**Grid Code
Modification
Recommendation Form**

Title of Recommended Proposal: MPID 302 Correction of 220kV P/Q graph for remote-end Interconnector Converter Stations

MPID: 302

Date:	26/01/2023
Recommended at GCRP Meeting No.:	GCRP Meeting 09/11/2022
Grid Code Version:	Version 11
Grid Code Section(s) Impacted by Recommended Proposal:	CC.7.5.10 (f)

CC.7.5.10 Interconnector Reactive Power

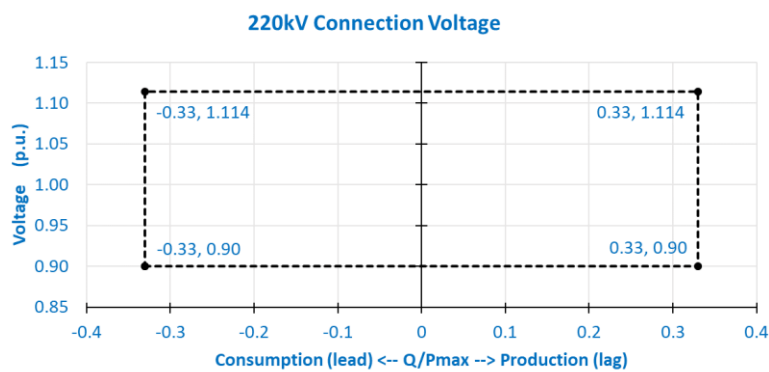
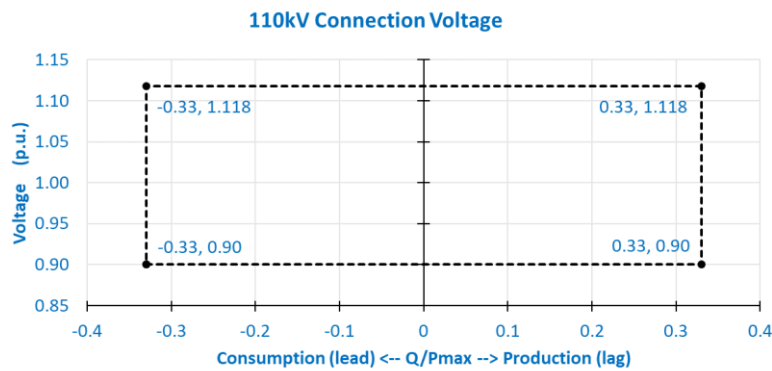
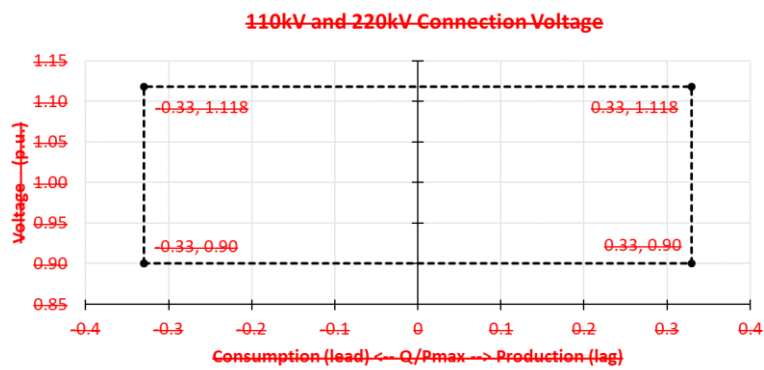
The graphs within clause CC.7.5.10(f) show a maximum voltage withstand capability of 1.118p.u. for connections at 110 kV and at 220 kV. In the case of 220 kV, this would require equipment to have the capability to continually withstand 246.4 kV. As per clause CC.8.3.2, the maximum transmission system voltages during a transmission fault for 220 kV are nominally 245 kV. This equates to an upper voltage limit of 1.114p.u. for 220 kV transmission systems.

To rectify this error in clause CC.7.5.10(f), we propose separating out the graphs for 110 kV and 220 kV, retaining the upper voltage limit for 110 kV systems of 1.118 p.u. and correcting the upper voltage limit for 220 kV systems to 1.114 p.u.

Deleted text in ~~strike-through red font~~ and new text highlighted in **blue font**

- (f) A remote end **Interconnector Converter Station** shall be capable of providing **Reactive Power** as per the following requirement at its maximum **Active Power** transmission capacity (P_{max}) at the **Connection Point**:
